Addendum to the Final Environmental Impact Statement - Baffinland Response to Technical Comments November 15, 2013

Qikiqtani Inuit Association		Baffinland's Response
Number	Recommendation	
<p>Note: See Baffinland Response to Project Certificate 005 Amendment Considerations attached for suggested word changes and new conditions; also see Appendix A, where referenced, for more detailed responses to technical comments.</p>		
FM-01	<p>It is recommended that dust dispersal modeling be revisited to reduce uncertainty and inform monitoring. The quantity and chemical composition of dust entering aquatic systems should be monitored to ensure that mitigation measures are effective. Sediment impact thresholds should be established for Arctic char, and possibly other taxa, to inform impact assessment, monitoring, and mitigation.</p>	<p>Dust dispersion modelling presented in the FEIS was “worst case” as it involved highly conservative assumptions and no dust controls. The FEIS Addendum considered dust controls and other refinements to the model. This is the reason for the reduction in dust deposition despite the overall tonnage increasing with the ERP from 18 to 21.5 Mt/a.</p> <p>Nonetheless,

Figure 1: Caribou decision tree

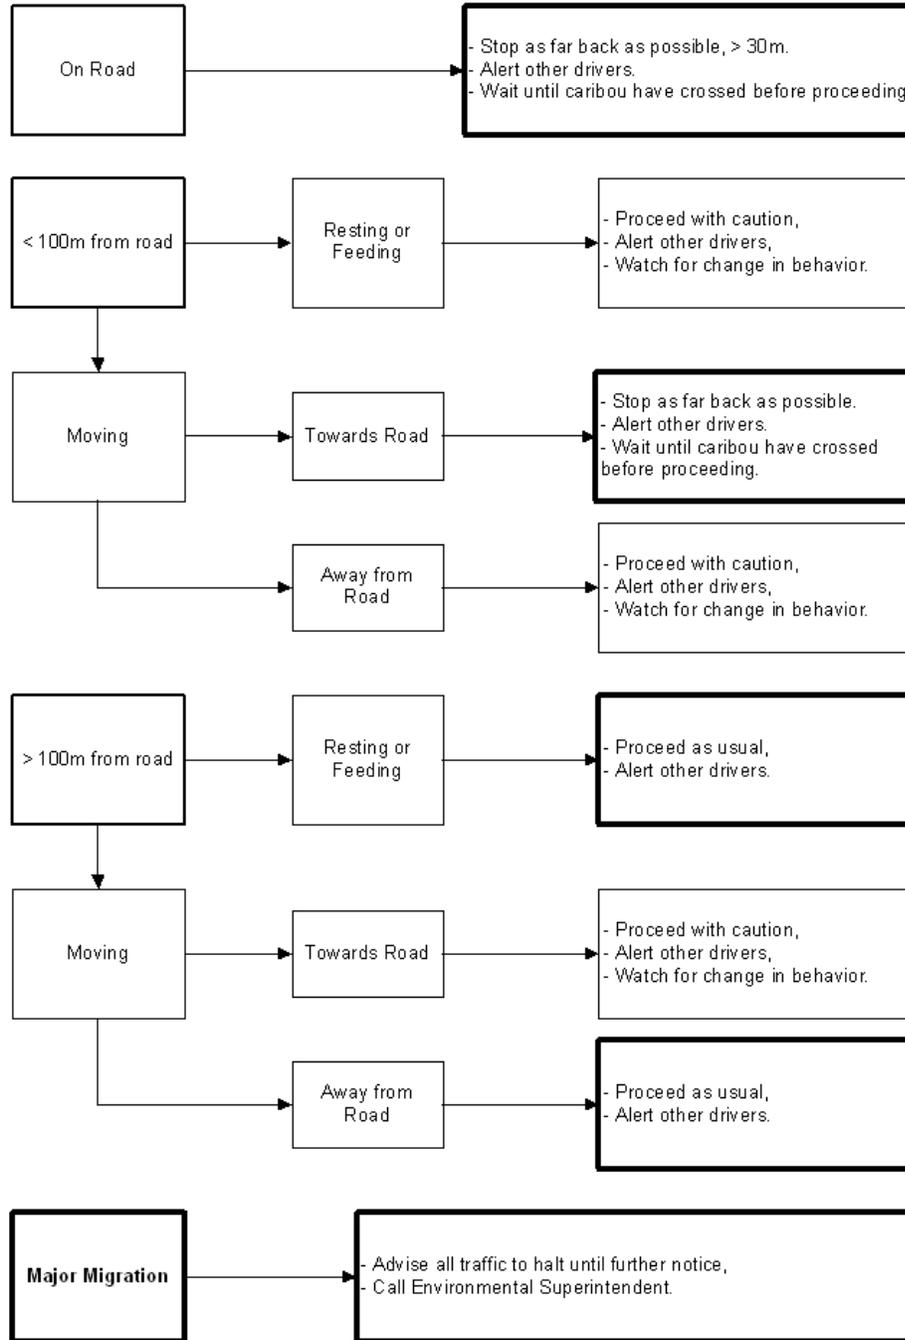
The Proponent must re-evaluate the potential impact on caribou movement of upwards of 200 trucks per day, the majority of them haul trucks, travelling along the Tote Road for the life of the mine. This re-evaluation should include revisions to the mitigation and adaptive monitoring plans and an assessment of residual impacts after mitigation.

The Roads Management Plan should specify how caribou presence on and in the vicinity will be monitored and what thresholds (other than the tracks) will be used to trigger specific levels of traffic management. Baffinland should investigate dash camera technology and wildlife road surveillance systems to prevent collisions and use remote camera monitoring to describe caribou use of the road corridor.

- Modified embankment heights and finer fill material at trails that cross the road (e.g., caribou crossings);
- Snow bank height maintained at less than 1 m;
- Operator radio communication as an early warning of caribou to approaching vehicles;
- Road signage identifying known crossing areas;
- Wildlife right-of-way policy; and
- Implementation of the caribou decision tree (see attachment).

QIA's suggestion for dash-mount cameras is not being considered as a monitoring tool. Communication among drivers, check-in at gates for wildlife observations, height-of-land surveys and follow-up investigations of all mortality events are sufficient to monitor and mitigate potential effects on caribou movement.
